Project	<b>IEEE 802.16 Broadband Wireless Access Working Group</b> < <a href="http://ieee802.org/16">http://ieee802.org/16</a> >	
Title	<b>2-antenna MIMO pilot allocation for PUSC/FUSC</b>	
Date Submitted	<b>2005-01-20</b>	
Source:	Jianglei Ma, Peiyong Zhu, Wen Tong, Ming Jia, Mo-Han Fong, Hang Zhang, Brian Johnson Nortel Networks 3500 Carling Avenue Ottawa, ON. K2H 8E9 CANADA	Voice: (613)-765-8089 Fax: (613)-765-7723  <a href="mailto:pyzhu@nortelnetworks.com">pyzhu@nortelnetworks.com</a>
Re:	Call for Reply Comments regarding the Maintenance Task Group Comment Report 80216maint-04_09.zip	
Abstract	In this contribution, we propose to clarify the 2-antenna MIMO pilot allocation for PUSC/FUSC	
Purpose	The contribution should be considered by Maintenance group within comment resolution Procedure. <a href="#">Corrections in Figure and typos in blue font.</a>	
Notice	This document has been prepared to assist IEEE 802.16. It is offered as a basis for discussion and is not binding on the contributing individual(s) or organization(s). The material in this document is subject to change in form and content after further study. The contributor(s) reserve(s) the right to add, amend or withdraw

Figure 245 – Cluster structure

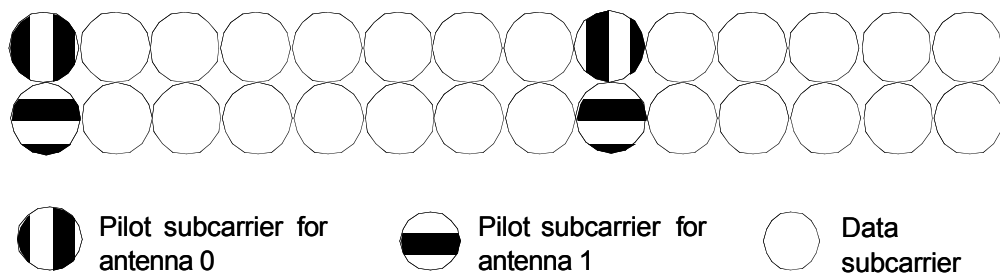
#### Section 8.4.8.1.2.1.1 STC using 2 antennas in PUSC Modify Figure 245 and 246

The clusters composing the subchannels used by the STC mode shall be allocated and subcarriers numbered as defined in 8.4.6.2. The cluster structure of the subchannels allocated for STC is slightly modified to fit the STC requirements. The structure shall be modified as depicted in Figure 245 (switching 2 pilot carriers ~~the odd symbol~~ with 2 data carriers ~~from the even symbols separately~~, switching of the data carriers and the pilots carriers shall be performed after constellation mapping, therefore maintaining all the encoding scheme and the subchannel allocation scheme). In this scheme, transmission on regular subchannels and STC subchannels is possible and is determined by the MAC layer (the allocation is performed by allocating major groups of subchannels for regular or STC transmission). The transmission of the data shall be performed in pairs of symbols as illustrated in Figure 246 ~~247~~.

The pilot locations in PUSC cluster shall obey the following rule:

$$\text{PilotsLocation} = (\text{PUSC\_PairNumber}) \bmod(2) * 4 + \text{PUSC\_Pilot\_Location}$$

where PUSC\_PairNumber is the OFDM symbol pair index in each PUSC allocation and counts from 0 to 1.

PUSC\_Pilot\_Location = 0, 8 is the frequency offset of the pilot carriers in each cluster.

Figure 246—STC usage with PUSC

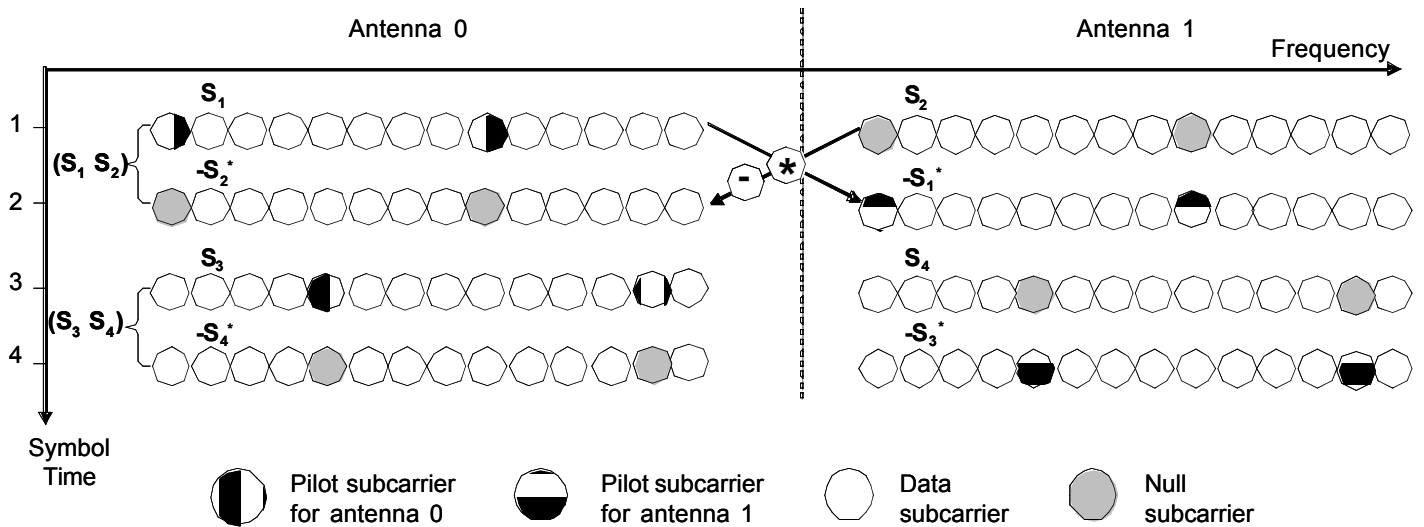
Replace Figure 246(need modify)
